AEROSTAR SERVICE LETTER 103

11/01/90

- Subject:** Springtop paravent modification
- Applicability:** Aerostar RX-7; Date of manufacture from 5/86 to 11/90.
Aerostar RX-8; All models manufactured before 11/90.
S55-A, S57-A, S60-A; Date of manufacture from 9/88 to 11/90.

FIGURE

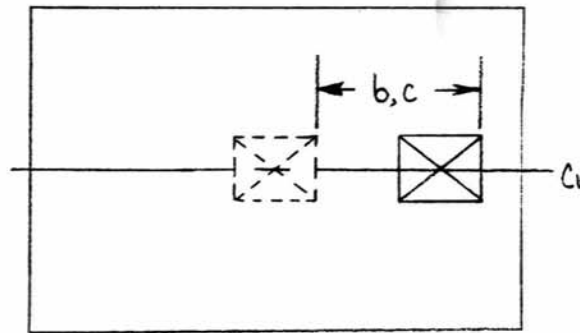
- 1) First, verify that the distance from the box-x (connecting overstrap to top-cap) to the first circumferential "spider web" in the port along the radial measures 24 in. +/- 1 in. (See Fig. 1) If this dimension is not met, the balloon is not affected by this service letter.

- 2) Measure three inches radially outward (towards the port edge) from the box-x location on the overstrap, and make a mark. (3 locations RX series, 5 locations S series).

- 3) Carefully remove the box-x stitching which connects the overstraps to the top-cap.
- 4) Refer to Figure 1. Except for the center (A) reinforcement patch, the box-x is not re-sewn to the middle of the patch, but is offset as shown. The object of this offset is to preserve the fullness in the vent area of the top-cap; thus the patches are moved towards the center of the vent. Identify each patch as (A), (B), or (C) and mark the offset on the patch.

- 5) Using a single needle machine with "F" thread, (6-9 stitches/in., thread type V-T-285 polyester, Type I or II, Class 1 or 3), sew a box-x connecting the top-cap to the overstrap at the marked locations.
